## FORD E4OD "UPDATE HANDBOOK"

### INDEX

Figure 69  
AUTOMATIC TRANSMISSION SERVICE GROUP

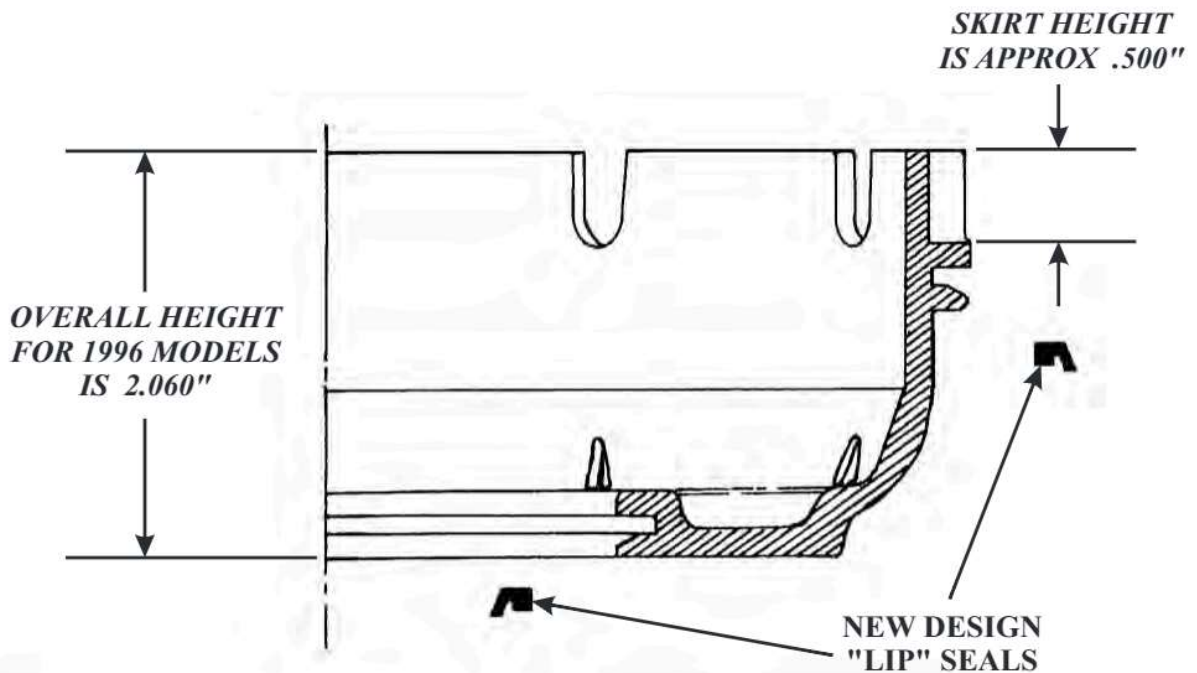
- (1) REVERSE CLUTCH PISTON SEALS - Change from the previous "Square" cut seals to the new design "Lip" seals, for increased sealing ability. Refer to Figures 68, 69 and 70.

- (2) REVERSE PISTON - Seal grooves in the piston are machined differently to accommodate the new design lip seals. The reverse piston skirt is also .140" shorter than the previous piston, to accommodate the added cushion (Wave) plate in the reverse clutch pack. This will obviously also affect the overall height of the piston. Refer to Figures 68, 69 and 70.  
The pistons can be identified by the "Rough Forging" number, as shown in Figures 68 and 69.

Figure 70  
AUTOMATIC TRANSMISSION SERVICE GROUP

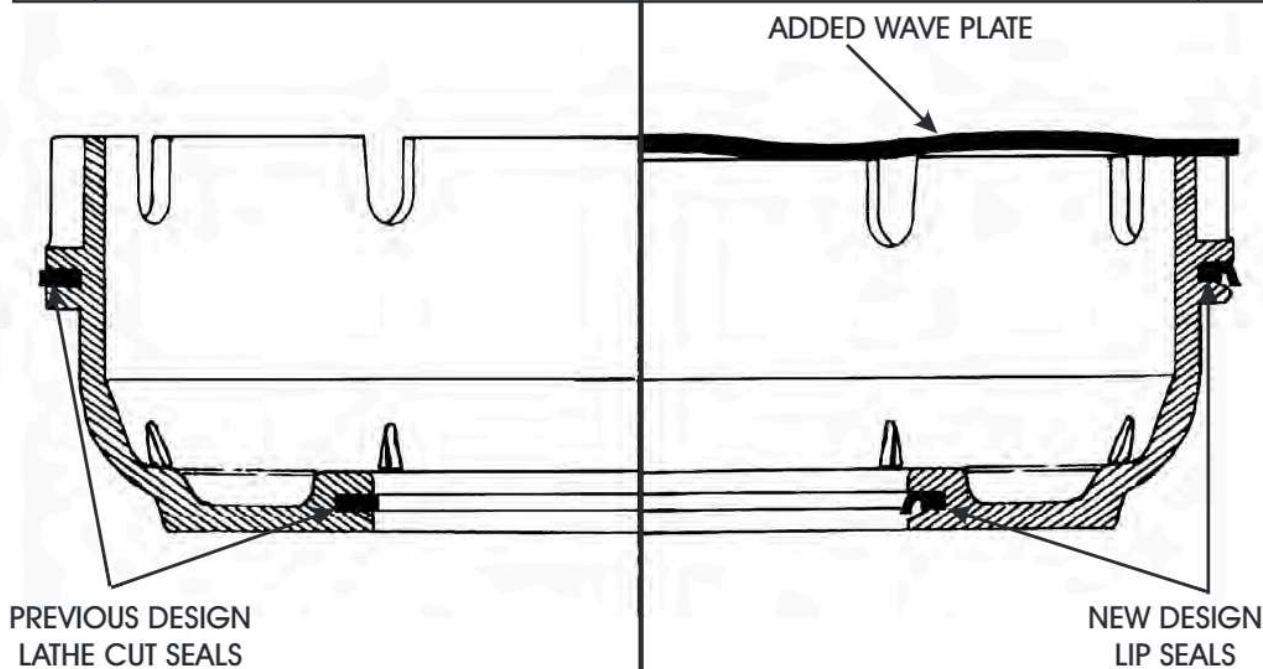
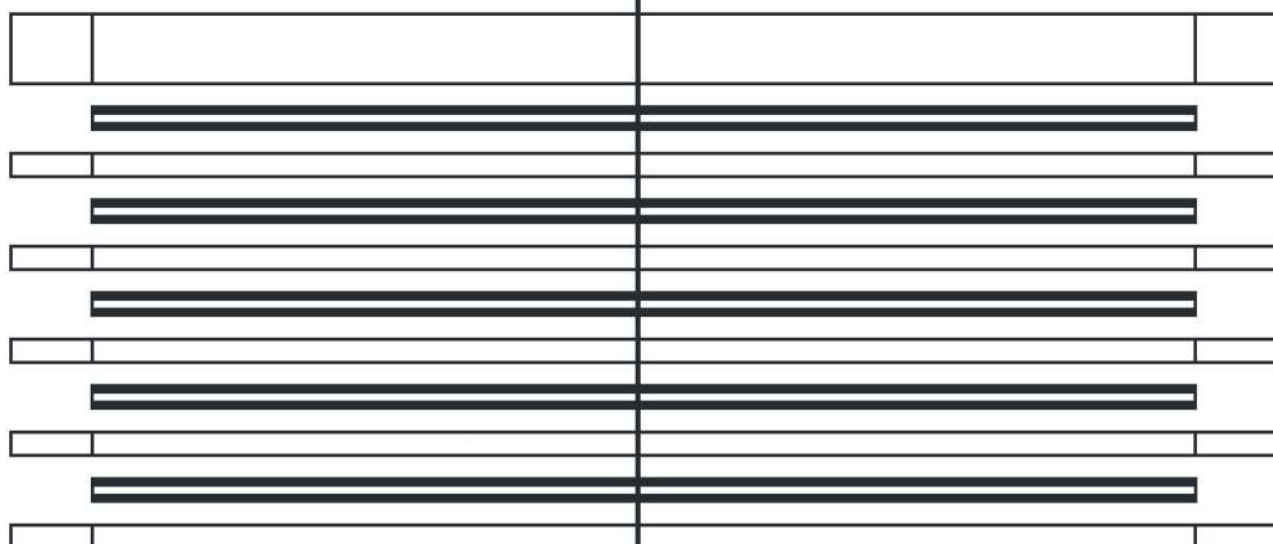
- (4) CUSHION (WAVE) PLATE - Added to the reverse clutch pack to cushion the reverse clutch apply, as shown in Figure 70. The new cushion plate when it is not compressed, is .140" in height and the nominal thickness is .080".

Figure 77  
AUTOMATIC TRANSMISSION SERVICE GROUP

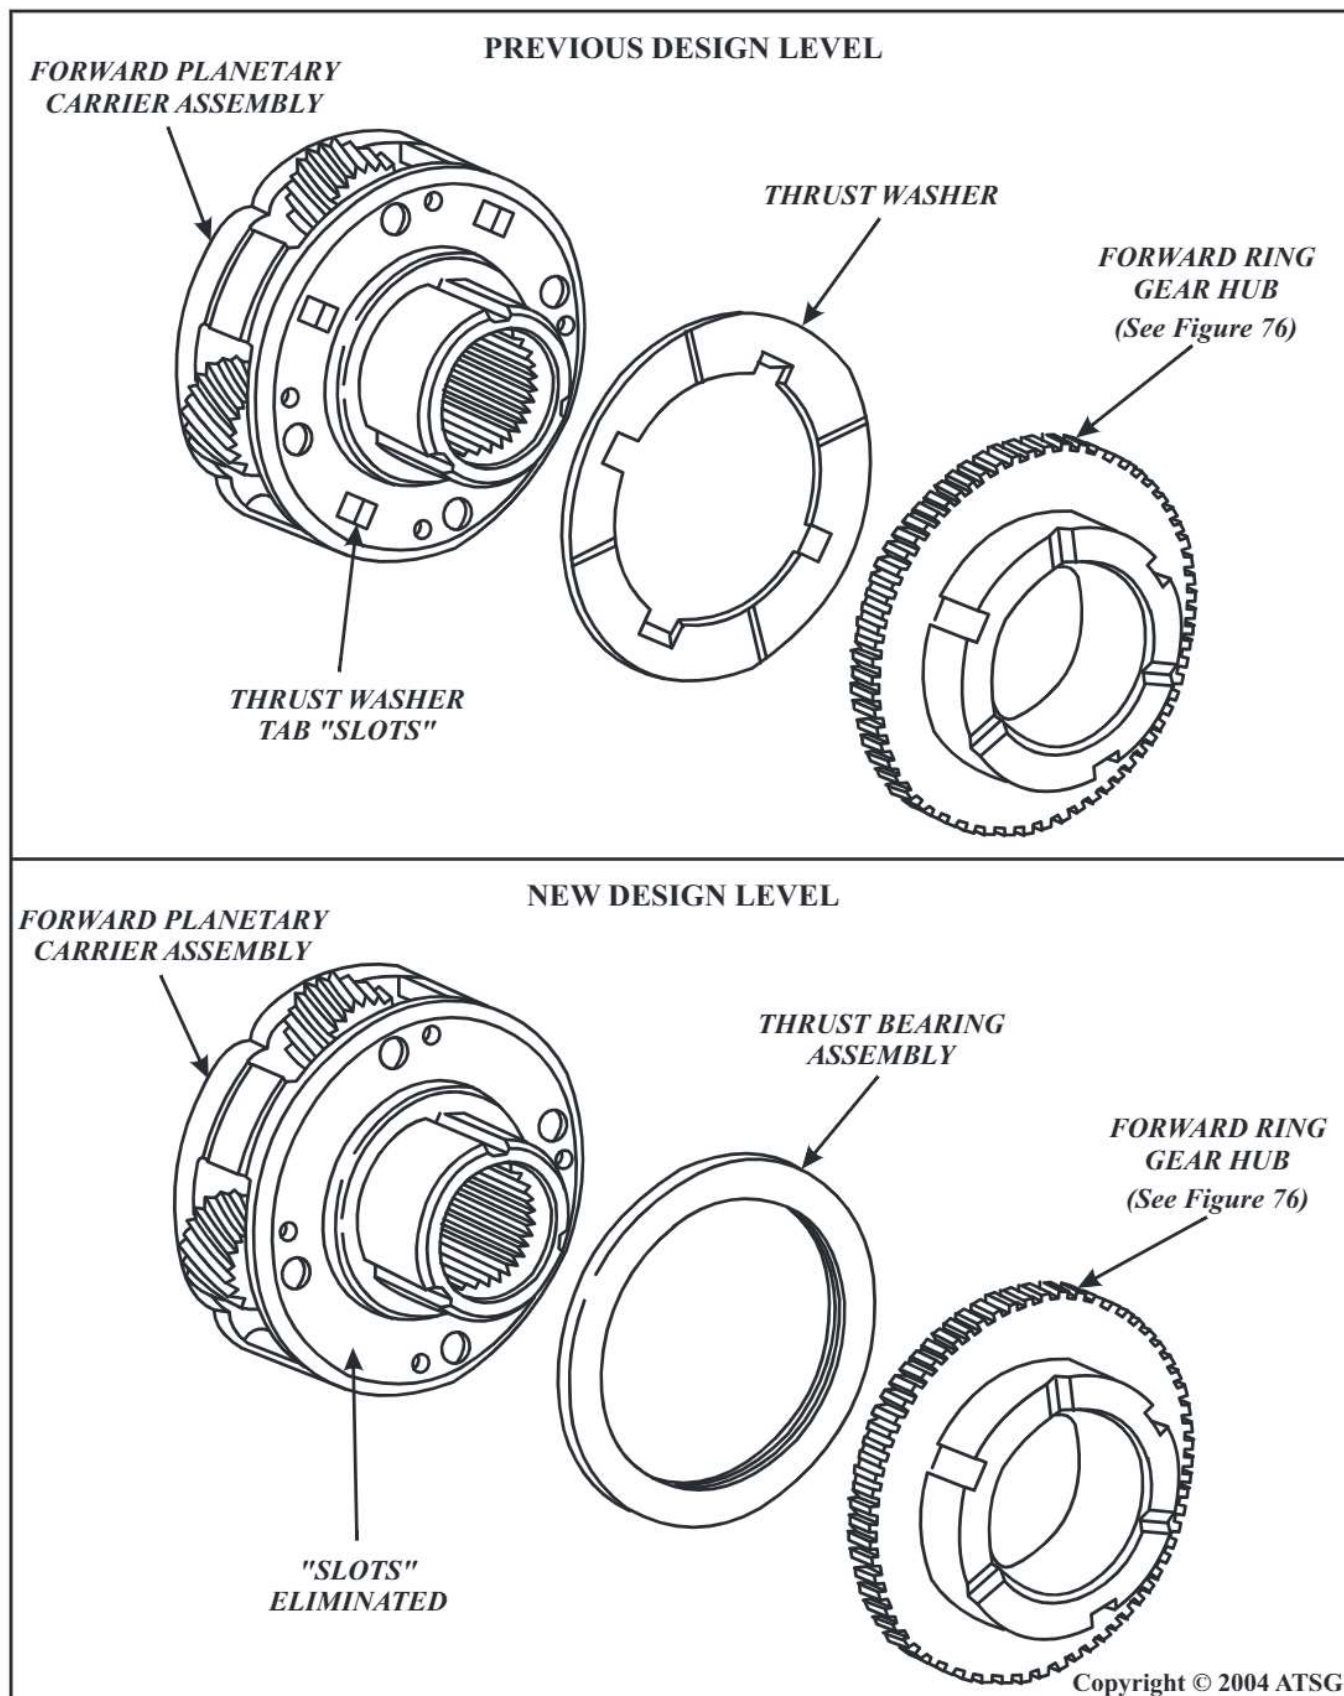
- (2) New design Thrust Bearing must be used only with the new design Ring Gear Hub. It cannot be used on any previous models (See Figure 76).
- (3) There is also a new part number for the Forward Planetary Carrier, with no dimensional changes, and will retro-fit back on all previous models, but, **some** of the new part number carriers will not be cut to accept the four tang thrust washer. In that case you will have to install the new thrust bearing, which means you will also have to replace the ring gear hub with the new design level (See Figure 77).

Figure 78

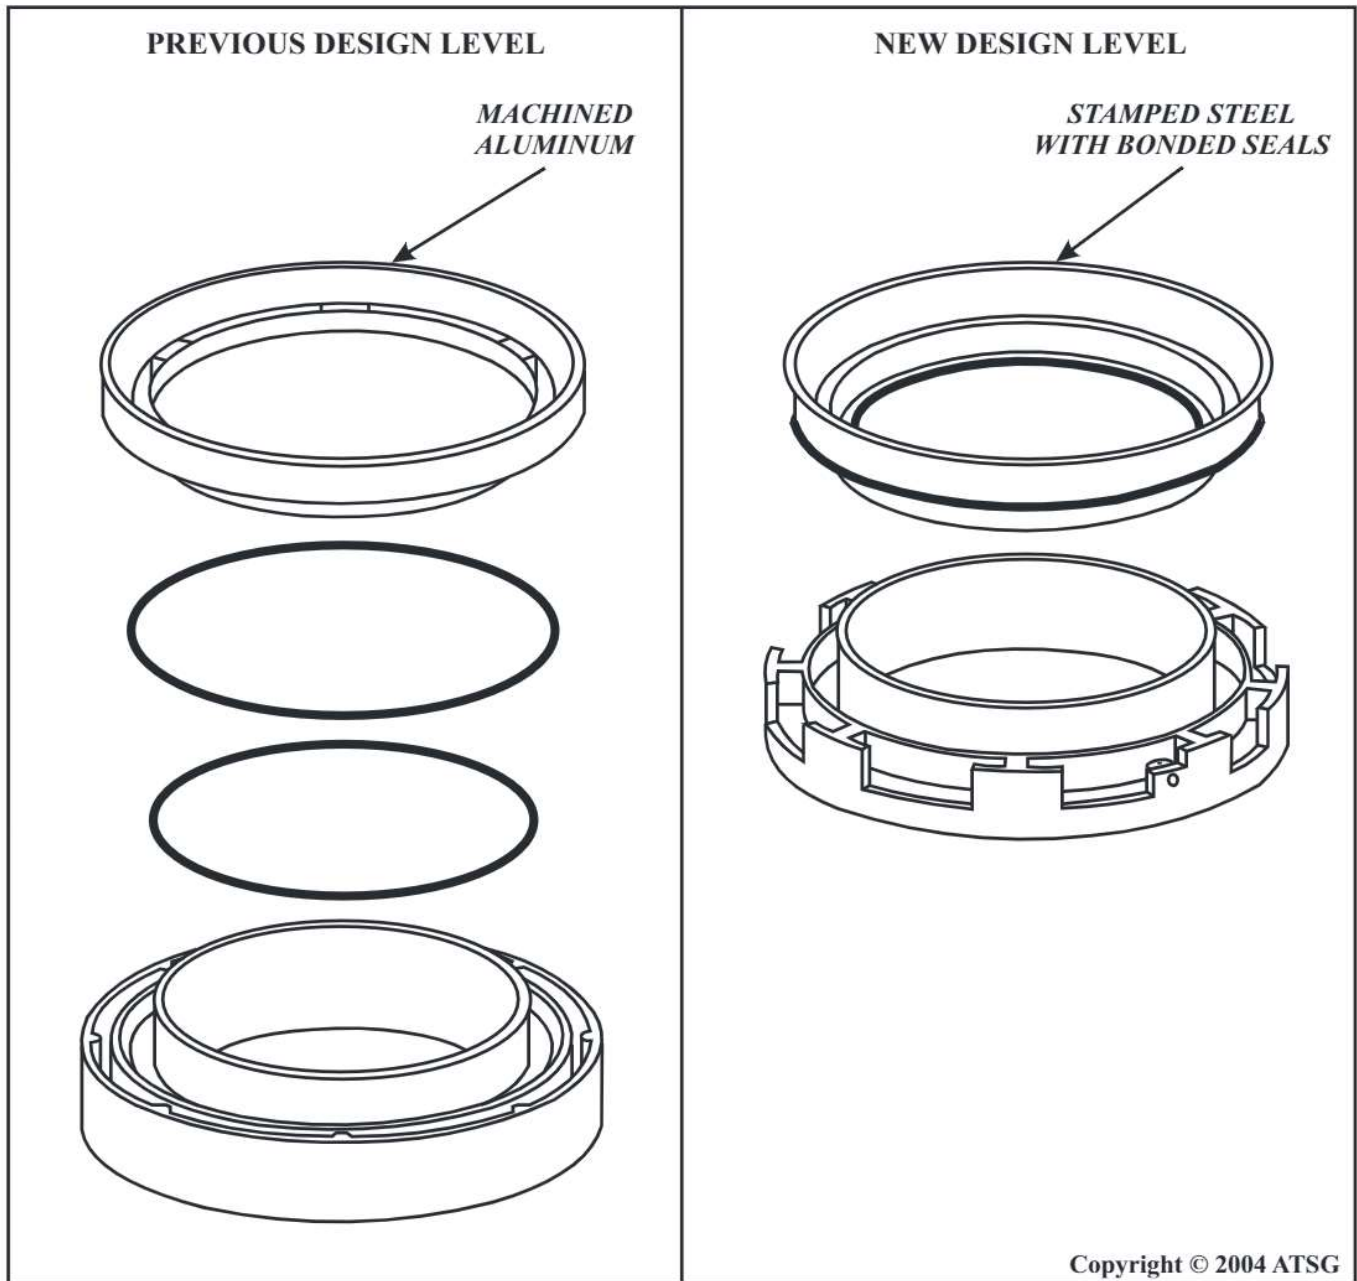
**CHANGE:** Some 1996-1997 vehicles equipped with the E4OD transmission were built with a new design level overdrive clutch piston, with the seals bonded to the piston (See Figure 78).

- (1) OVERDRIVE PISTON - Now stamped steel with moulded rubber inner and outer seals on the piston assembly, instead of the previous machined aluminum, as shown in Figure 78.
- (2) OVERDRIVE/INTERMEDIATE CLUTCH CYLINDER - Major casting changes to clutch cylinder, to accommodate the new design level bonded piston, as shown in Figure 78.

Figure 79

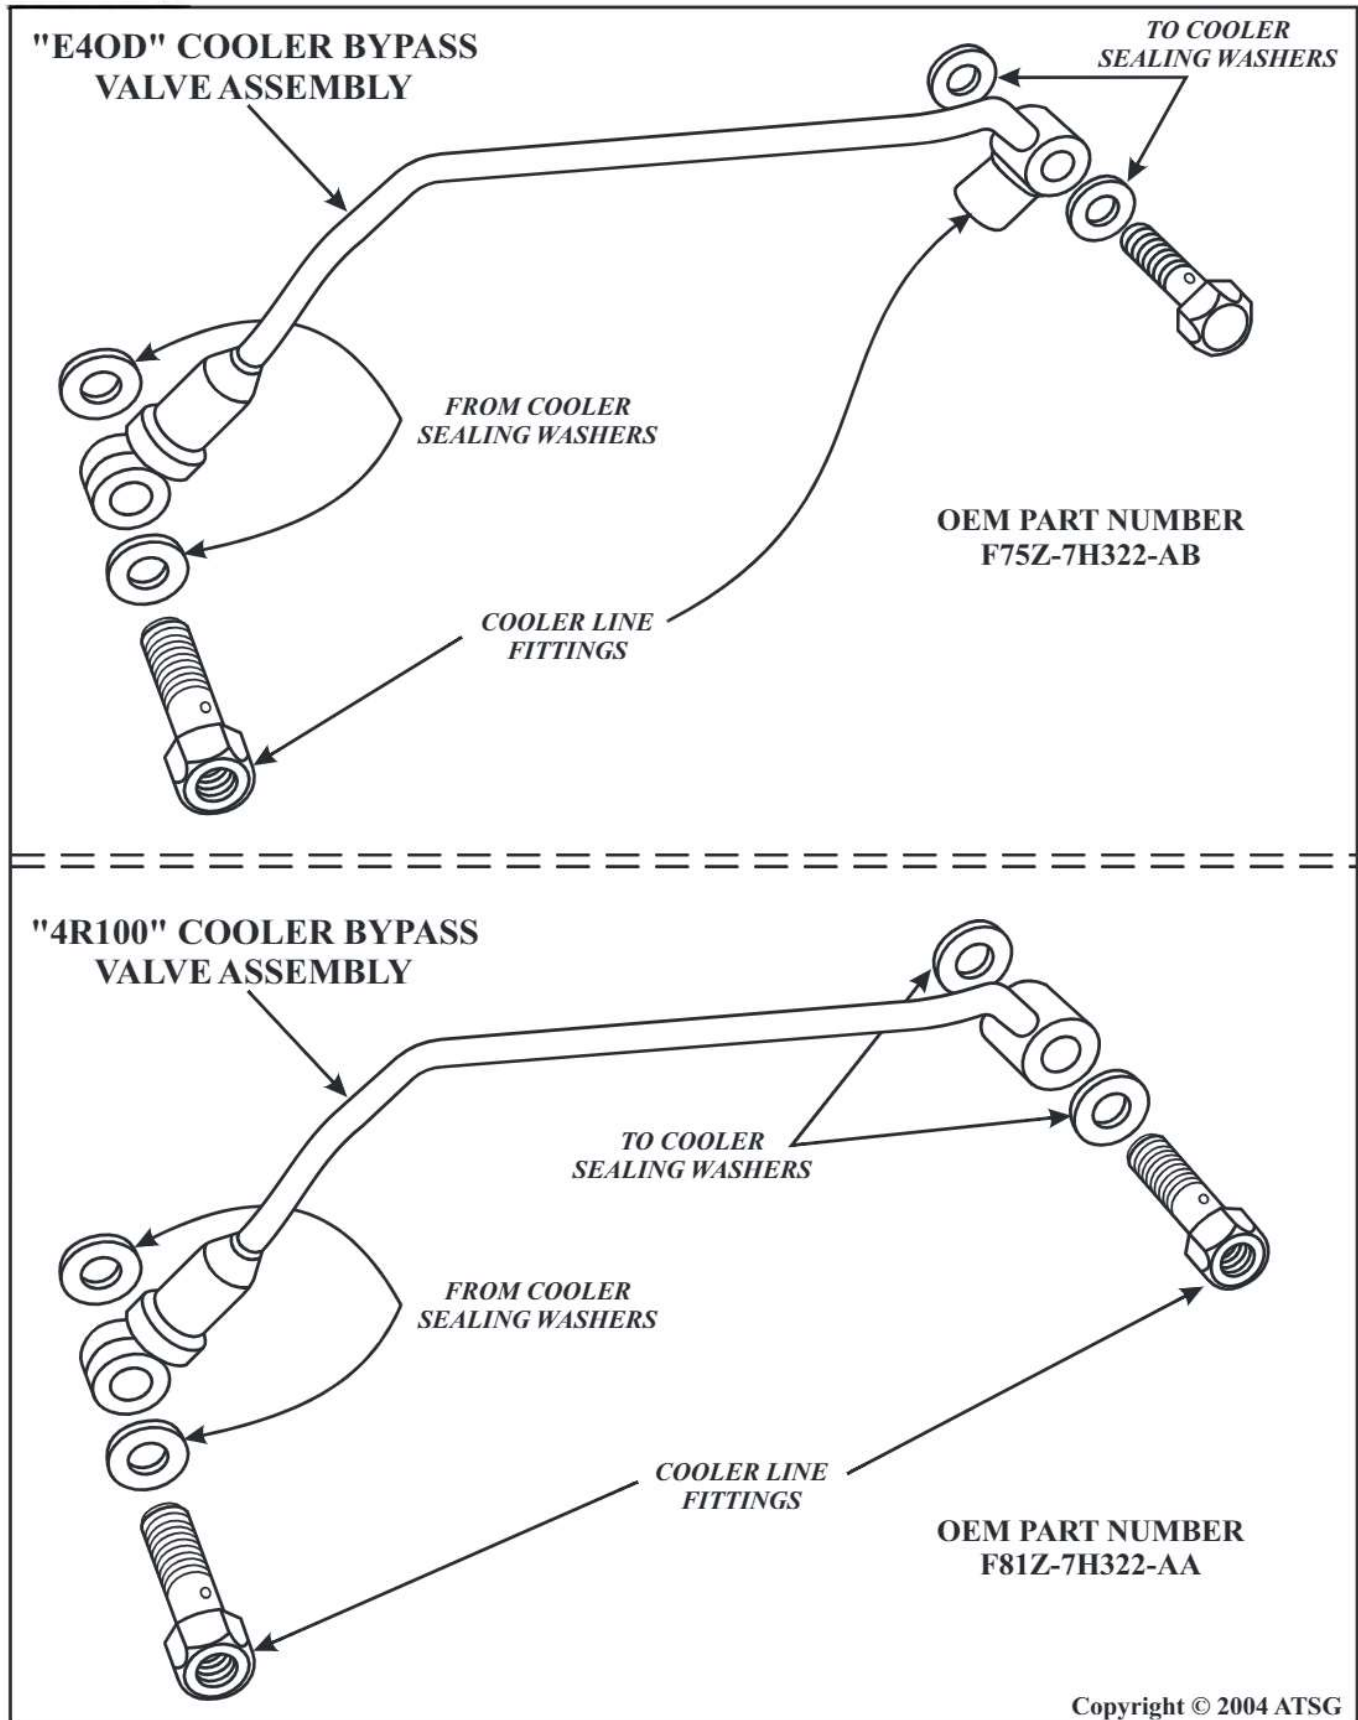
**CHANGE:** Some 1997 Econoline, Expedition, F-150 Trucks and F-250 Trucks have been equipped with a Cooler Bypass Valve Assembly that requires sealing washers on both the "To Cooler" end and "From Cooler" end of the bypass valve assembly, as shown in Figure 79.

- (1) COOLER BYPASS VALVE ASSEMBLY - Added between the cooler line fittings in the case, to increase lube flow during cold weather operation (See Figure 79).
- (2) CASE FITTINGS - Requires special case fittings to retain the "Banjo" ends of the cooler bypass valve assembly into the transmission case (See Figure 79).
- (3) SEALING WASHERS - Requires sealing washers on both of the "Banjo" ends of the cooler bypass valve to seal properly (See Figure 79).

Figure 80

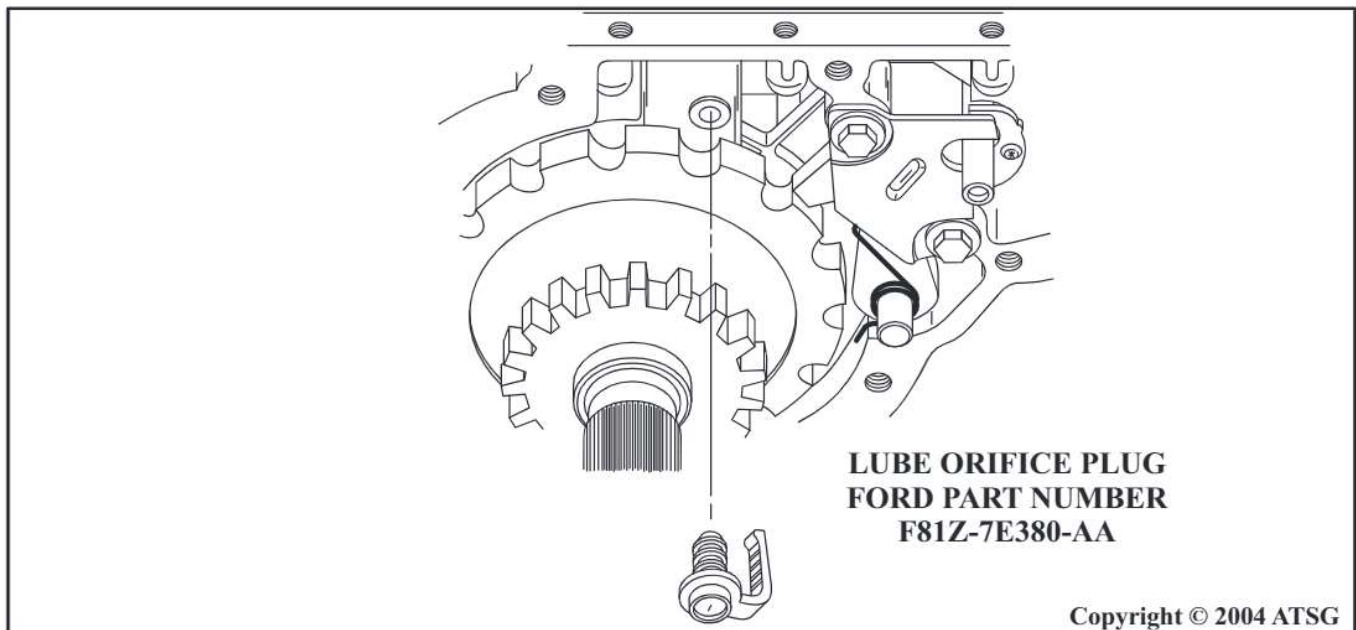
- (1) TRANSMISSION CASE - Added passage at the rear of transmission case to accept the added plastic lube orifice plug, as shown in Figure 80.
- (2) EXTENSION HOUSING - Added cast-in shoulder/boss that retains the added lube orifice plug in the transmission case, as shown in Figure 81.
